Subject: Exelon Nuclear Texas Holdings, LLC
Victoria County Station Early Site Permit Application
Response to Request for Additional Information Letter No. 06
NRC Docket No. 52-042

RAI 02.04.04-1:**Question:**

Figure 2.4.4-16 Finish Grading West of the Power Block and Location where Western Breach Begins

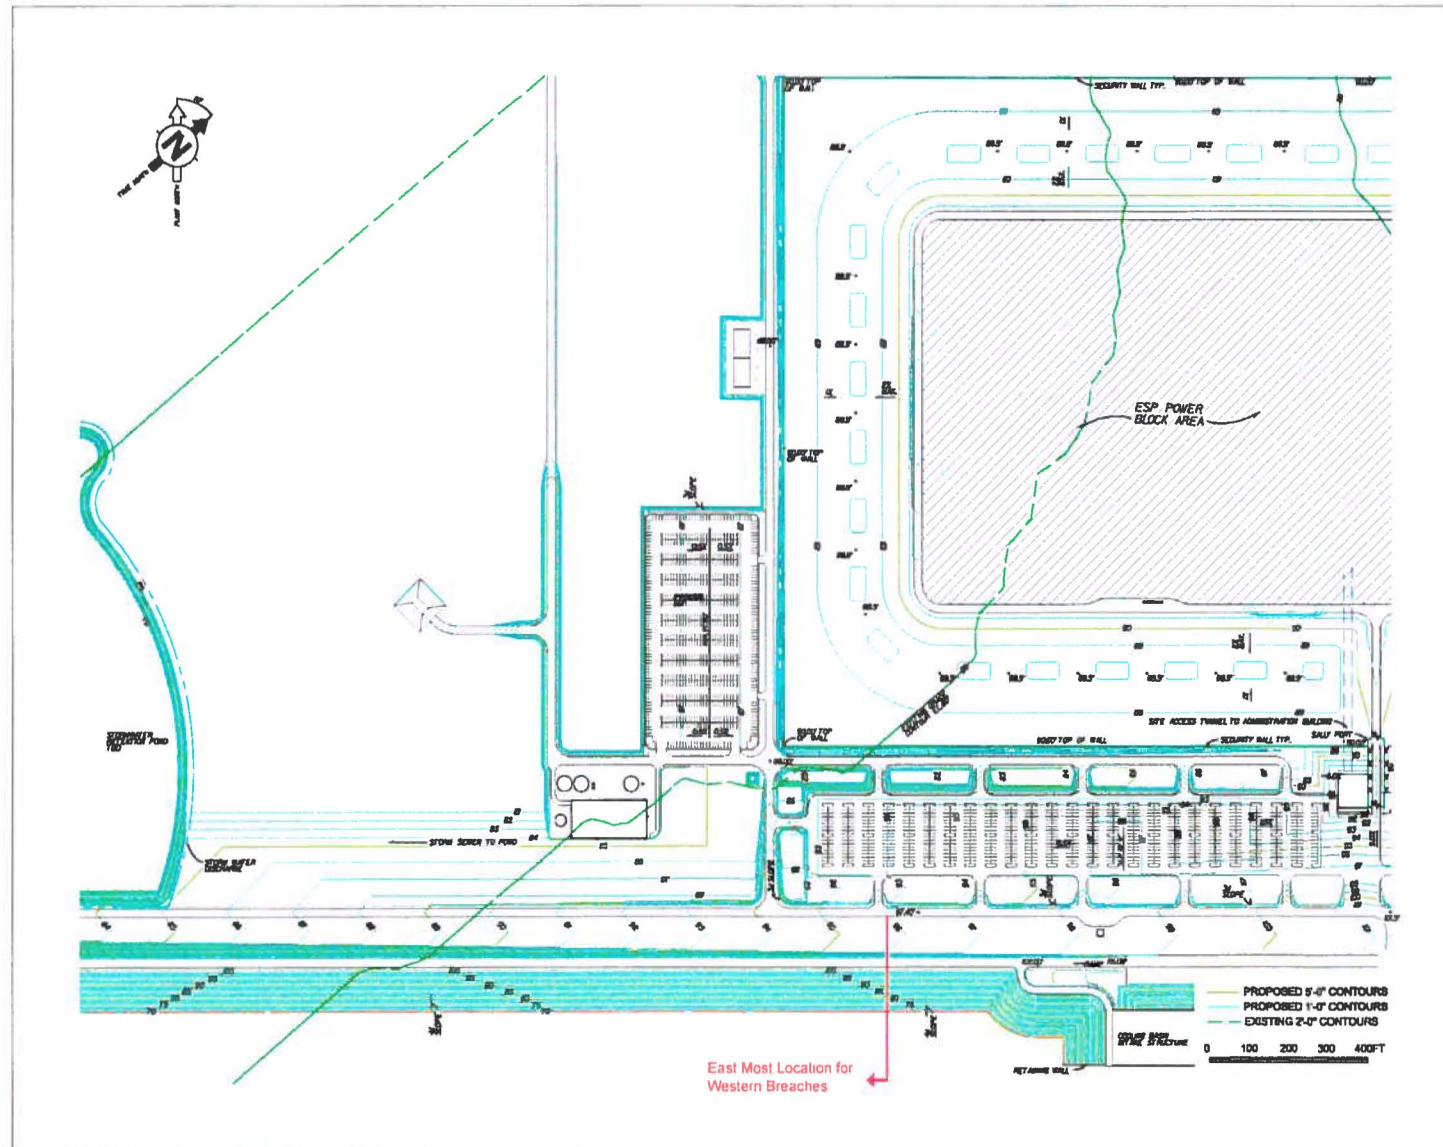
The staff has reviewed the application in accordance with the requirements of "Factors to be considered when evaluating sites" 10 CFR 100.20(c), and "Contents of application: technical information in the final safety analysis report" 10 CFR 52.79(a). The staff has reviewed FSAR Section 2.4.4, Potential Dam Failures and the dam breach outflow hydrographs for the postulated breach of the cooling basin. The outflow hydrographs are too short to determine if wave runup will impact the site and there is no discussion of the basis for selection of the breach location. Please describe the justification for breach locations and wave runup conclusions and provide a complete outflow recession curve.

As shown in SSAR Figures 2.4.4-16 and 2.4.4-17, the distance between the northern embankment of the cooling basin and the security wall is over 500 feet. The area in between is built up (with fill materials) to elevations in the general range of 86 to 102 feet NAVD 88, from the natural grade of about 80 feet (24.4 meters) NAVD 88. A local drainage ditch south of the security wall has invert elevations slightly lower than 86 feet (26.2 meters) NAVD 88. Specifically:

As described above, most of this built-up area is higher than or has similar elevation to the initial cooling basin level of 93.9 feet (28.6 meters) NAVD 88 for the postulated embankment breaches. It is therefore highly unlikely that the cooling basin will breach through the large amount of fill materials placed between the cooling basin and the security wall. Further towards the east and west, the grade elevations continue to decrease gradually, and the probability that a breach might occur increases slightly. Conservatively, the breach analysis in SSAR 2.4.4 postulates that the embankment would fail where the grade elevation immediately to the north of the embankment is below elevation 96.0 feet (29.3 meters) NAVD 88 on the west and 94.0 feet (28.7 meters) NAVD 88 on the east as shown in the revised SSAR Figures 2.4.4-16 and 2.4.4-17 (attached), respectively.

SSAR Subsection 2.4.4 will be modified to include the above discussion and revisions to SSAR Figures 2.4.4-16, 2.4.4-17, 2.4.4-23 and 2.4.4-26. The figures include details on breach locations. Figure 2.4.4-21 will be revised to make the water level scale consistent with the other figures.
